Amendment Notice 5

Licence Number	L8889/2015/1
Licence Holder	Eastern Metropolitan Regional Council
File Number:	DER2017/000777
Premises	Red Hill Waste Management Facility Lot 1 on Diagram 15239; Lot 2 on Diagram 68630; and Lot 11 on Diagram 69105 Toodyay Road, RED HILL; and Part of Lot 12 on Plan 26468 Toodyay Road, GIDGEGANNUP
Date of Amendment	01 November 2018

This notice is limited only to an amendment for Category 64 and 65 only in relation to a change to the construction and operation of one leachate pond (the leachate holding pond) originally approved under Amendment Notice 3 (dated 09 July 2018) of the Existing Licence. There are no proposed design changes to the evaporation ponds approved under Amendment Notice 3. Further no other changes to the aspects of the Existing Licence relating to Categories 12, 62 and 67A have been requested by the Licence Holder.

Design Drawing 1 – General Arrangement Plan for Leachate Ponds

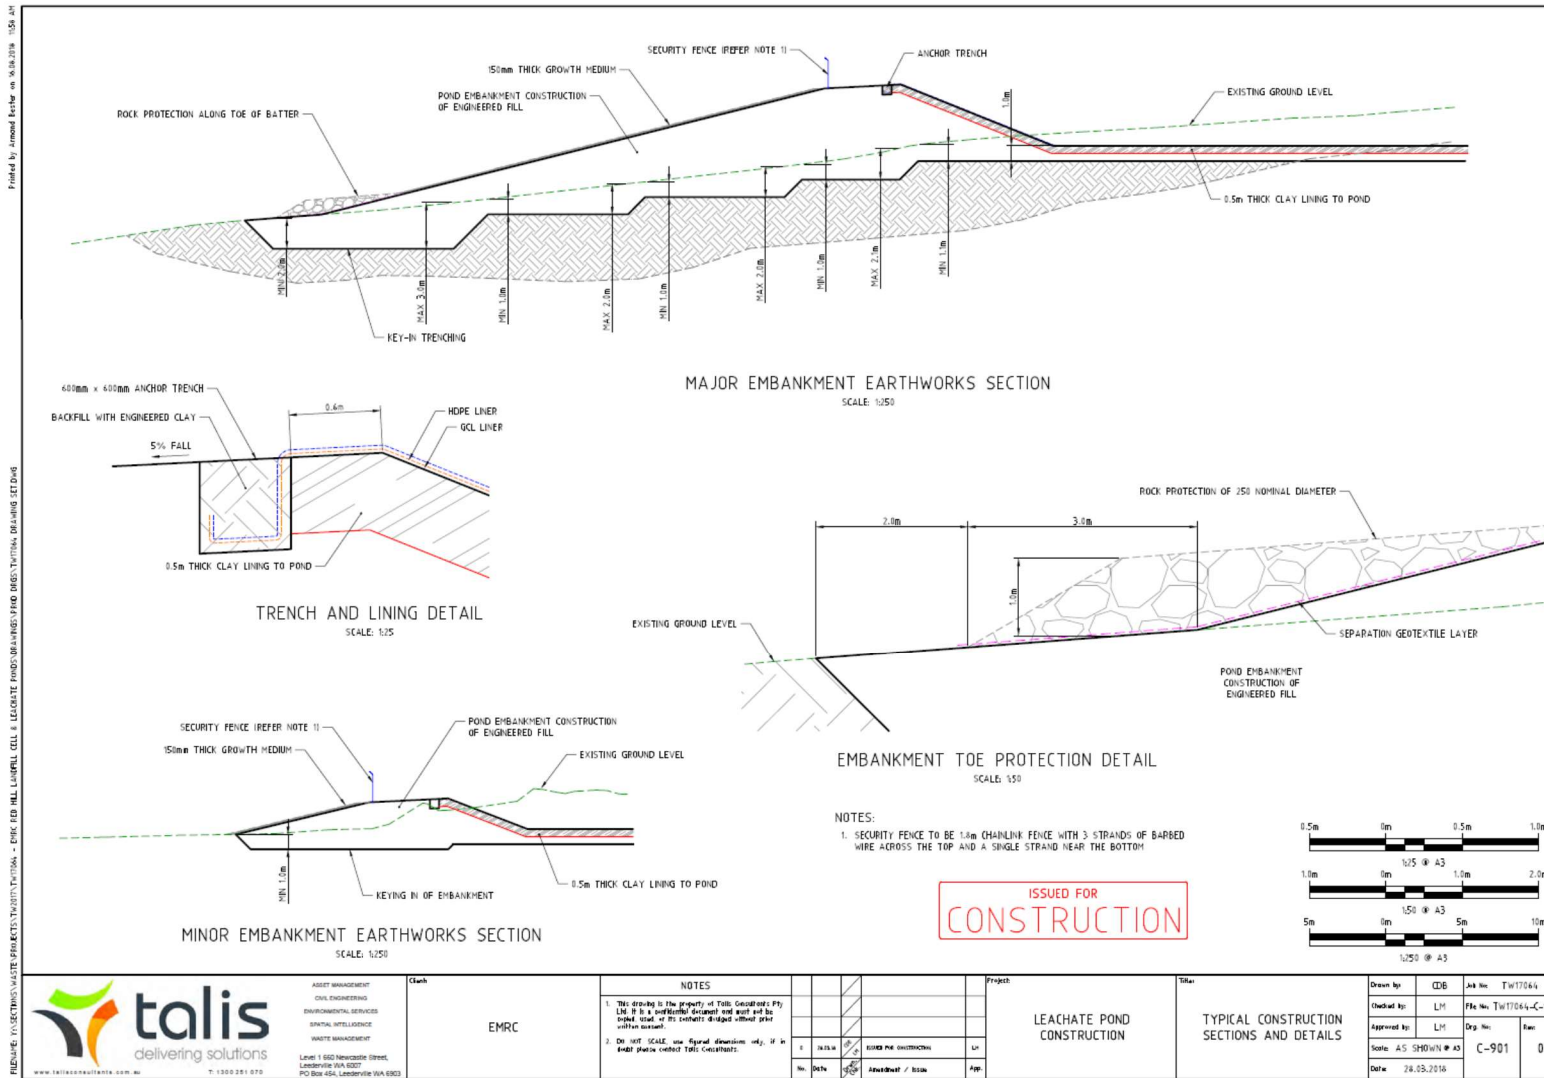
The proposed amendment includes an increase of the approved operational capacity of Holding Pond 1 (approved in Amendment Notice 3) by deepening the base of the pond by three (3) metres (m) from its current approved basal depth.. The leachate holding pond design specifications are as follows:

- The cross section 'XSECT B' (refer to updated Schedule 4 of proposed amendments in this notice – *Design Drawing 1*) has been re-analysed in its two component parts, the southern outer embankment and the northern embankment and cut slope;

3. Design Drawings 1, 2, 3 and 4 of Schedule 4 of the Licence are replaced by the following design drawings shown below:
